Addendum 157 – UN Regulation No. 158

Amendment 1

Supplement 1 to the original version of the Regulation – Date of entry into force:
22 June 2022

Uniform provisions concerning the approval of devices for reversing motion and motor vehicles with regard to the driver's awareness of vulnerable road users behind vehicles

"Annex 5

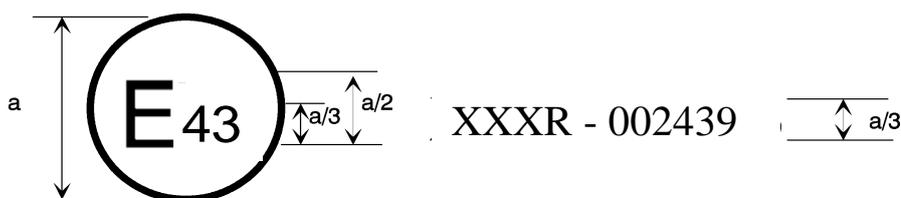
Annex 5, amend to read:

Arrangement of approval mark of a device for means of rear visibility

The above approval mark affixed to a device for means of rear visibility indicates that the device is a main Close-proximity rear-view device, which has been approved in Japan (E 43) pursuant to UN Regulation No. 158 and under approval number 002439. The first two digits of the approval number indicate that the approval was granted in accordance with the requirements of UN Regulation No. 158 in its original form.
